CERTIFICATE OF CORRECTIONS TO DESCRIPTION

WOODBIDGE 3RD. ADD.

Woodbridge 3rd. Add.

S/D No.: 86-8 Name: WOODBRIDGE 3RD ADDITION

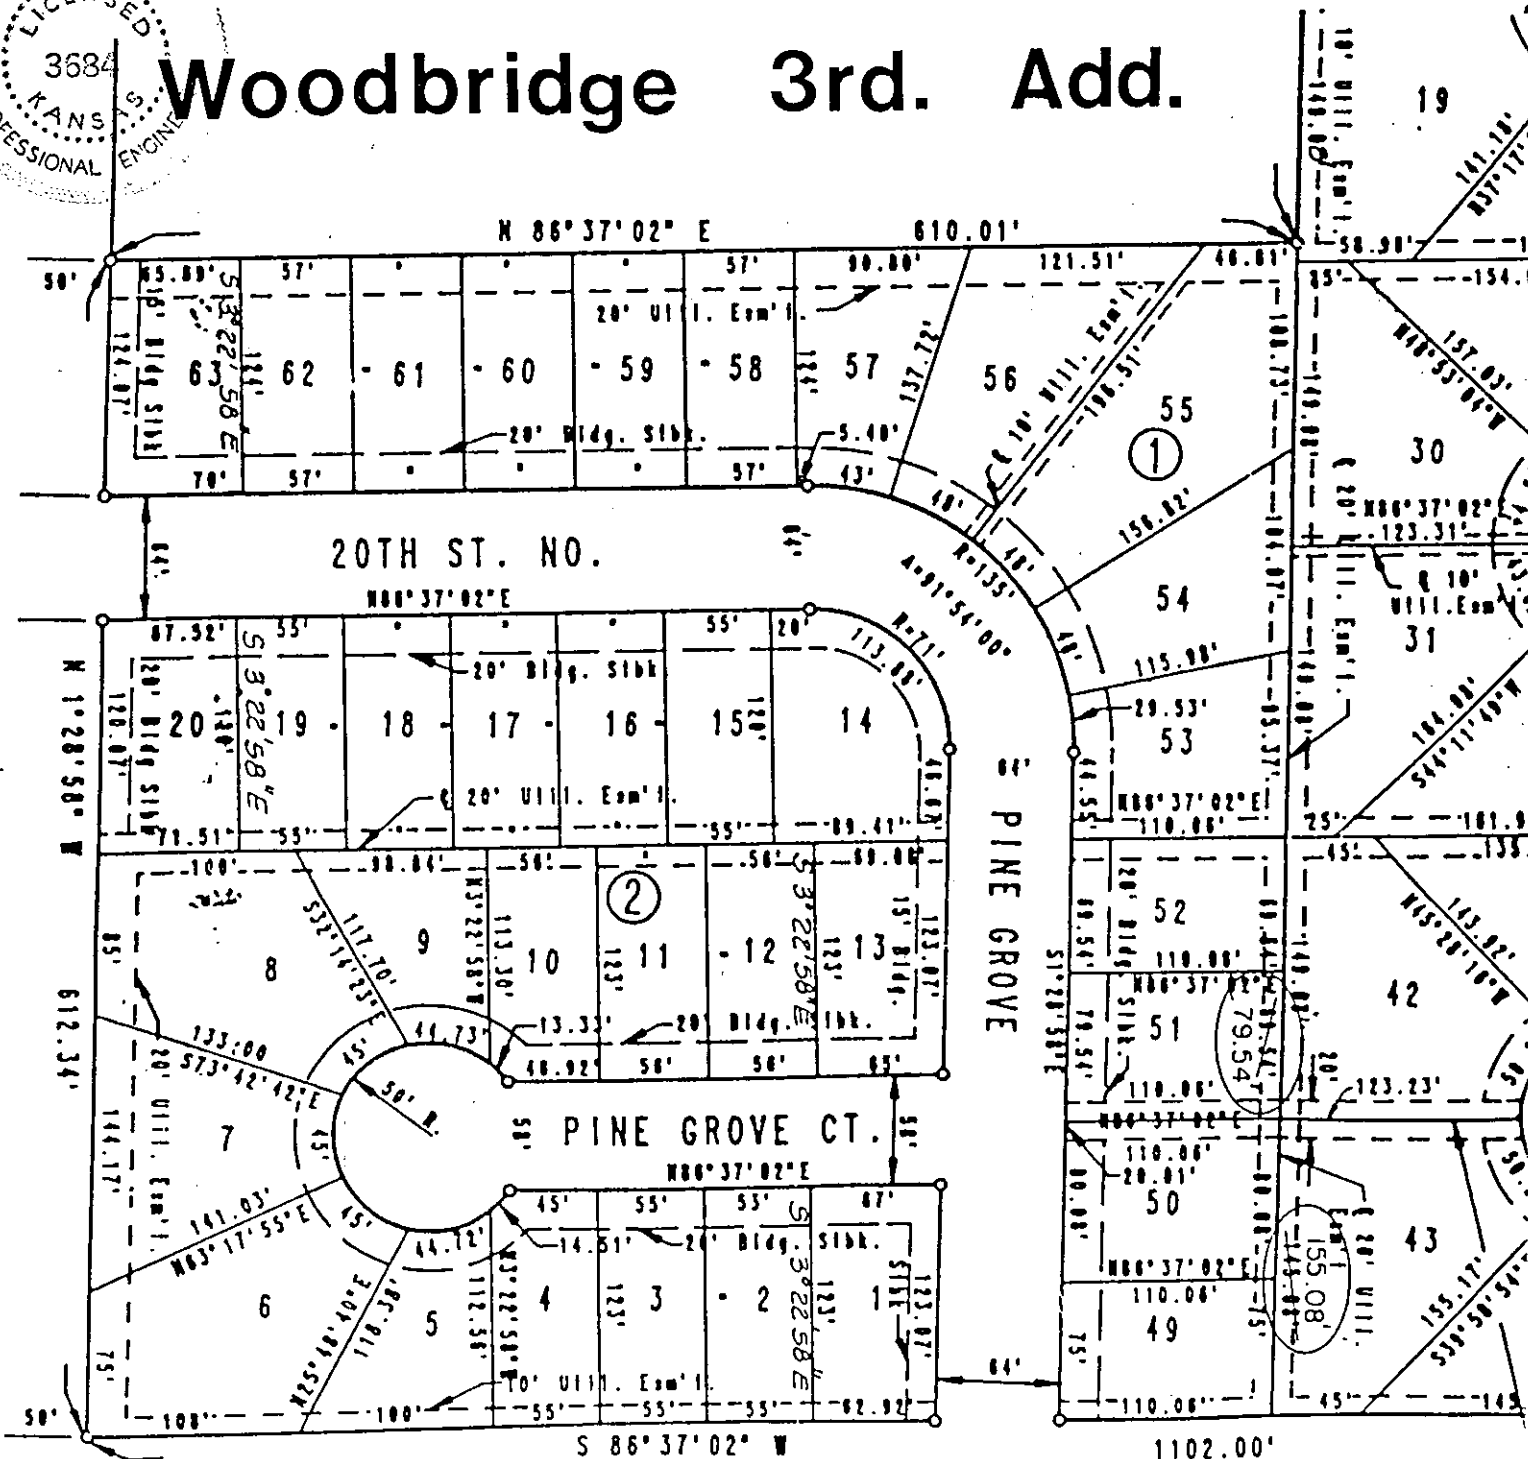
We, Professional Engineering Consultants, P.A., engineers in aforesaid county and state do hereby certify that a certain distance error exists on the plat drawing of Woodbridge 3rd Addition to Wichita, Sedgwick County, Kansas. The west line of Lot 43, Block 1 should be changed from 145.08 feet to 155.08 feet and the east line of Lot 51, Block 1, should be changed from 69.54 feet to 79.54 feet.

The accompanying drawing is a true and correct exhibit of the correction as noted.
